RE: St. Lucie Units 1 and 2
Docket Nos. 50-335 and 50-389
RAI Response for Addition of
Spent Fuel Pool Cask Pit Rack Amendment

RESPONSE TO
REQUEST FOR ADDITIONAL INFORMATION
CASK PIT RACKS LICENSE AMENDMENT REQUEST

ST. LUCIE PLANT, UNITS 1 AND 2

DOCKET NOS. 50-335 AND 50-389

FIGURE 5
FUEL AREA SAFE LOAD PATH

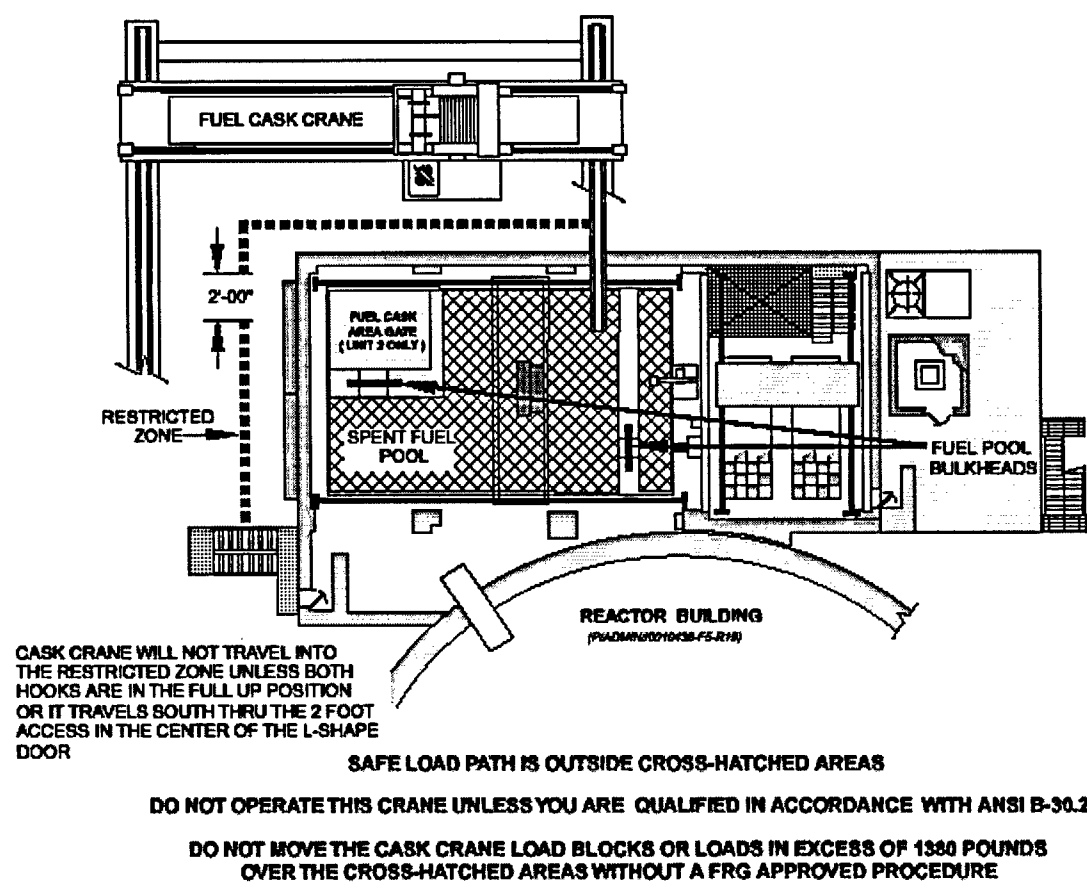
- (8) The submittal states that safe-load paths will be established for loads, specifically the spent fuel racks in and out of the cask pits. Explain the guidelines for establishing safe-load paths. In particular, address if the load could travel over spent fuel, any safety-related equipment, or any part of the spent fuel pool (e.g., weir wall).

The rack installations will follow the heavy load handling guidelines of St. Lucie Administrative Procedure 0010438, including the safe load paths established for the fuel handling areas depicted in Figure 5 of that procedure (a copy of which is attached). The Figure 5 safe load path for the cask crane on both units excludes the cross-hatched area over the entire spent fuel pool. As shown on Figure 5 and Unit 1 UFSAR Figure 9.1-15b, this load path restricts the crane main hook travel into the Fuel Handling Building to a two-foot-wide north/south corridor along the centerline of the L-shaped door opening into the building by the use of crane limit switches. The corridor terminates inside the fuel handling building at the approximate center of the cask pit. The objective of this restricted path is to allow crane access to the cask pit area while preventing the load from travel directly over spent fuel stored in the pool or the walls that separate the cask pit from the spent fuel pool. Because the cask pit rack is slightly smaller than the cask pit itself, the rack will be carefully lowered during installation to avoid contact with the cask pit walls.

When the cask pit rack is installed and contains fuel, the cask crane will be administratively prevented (blocked) from operating over the cask pit by use of a restricted area lockout keyswitch under the control of plant Operations. This lockout will protect any fuel stored in the cask pit rack from heavy loads and will prevent violating Technical Specification 3.9.7 weight restrictions over irradiated fuel.

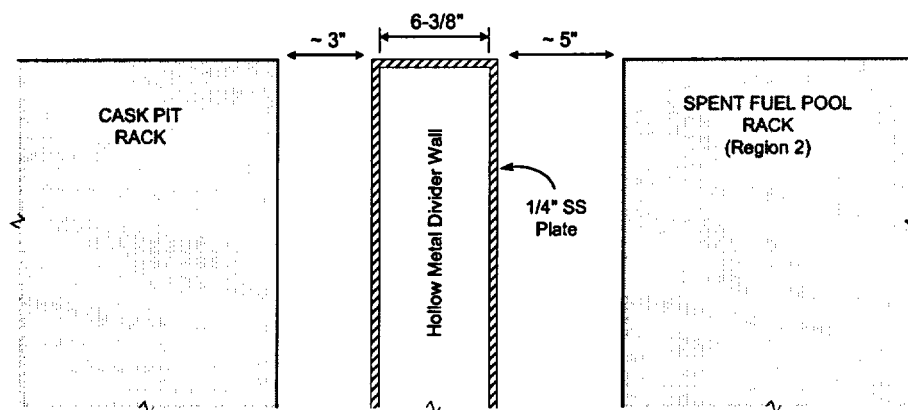
- (17) The current St. Lucie, Unit 2, spent fuel racks have a nominal 8.96-inch center-to-center distance between the fuel assemblies; however, the proposed amendment calls for a nominal 8.80-inch center-to-center distance between fuel assemblies placed in the cask pit storage rack. Please describe the basis for the reduced spacing and discuss how the change was accounted for in the reactivity calculations.

The Unit 2 cask pit storage rack cell pitch is less than the pitch of the current Unit 2 spent fuel racks because the new rack employs integral neutron absorbing material in the cell walls. The use of Boral panels between adjacent cells in the cask pit rack reduces the calculated k_{eff} for a given center-to-center spacing compared to the existing SFP racks.

The existing Unit 2 spent fuel storage racks do not contain either Boral or Boraflex neutron absorbing material. Reactivity control is achieved by use of (1) stainless steel L-inserts which provide some neutron absorption, (2) blocked-open cells (water gaps), and (3) the larger cell pitch (center-to-center spacing) identified in the Technical Specifications.

The Unit 2 cask pit rack reactivity calculation was based on the presence of Boral panels, an 8.80 inch pitch, and the related cell geometry depicted in Figure 4.2.2 of Enclosure 2 to the submittal.
